These comments are for "Regional Terrestrial Water Storage Changes in the Yangtze River Delta over the Recent 20 years" by Dr. Fengwei Wang. They investigate the terrestrial water and groundwater storage changes in the Yangtze River Delta. I think this manuscript lacks of discussion section, but this issue should be evaluated by Editor.

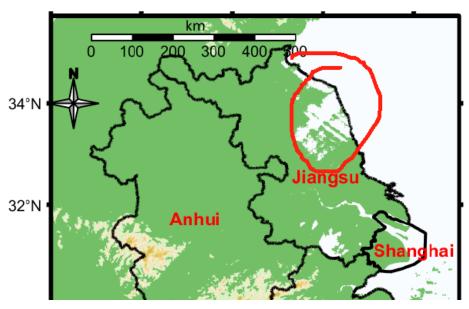
1) What is the white region in the north Jiangsu Province. Please explain this. What is the area of your study region? And the areas of four provinces. How do you consider the impact of small area in Shanghai City.
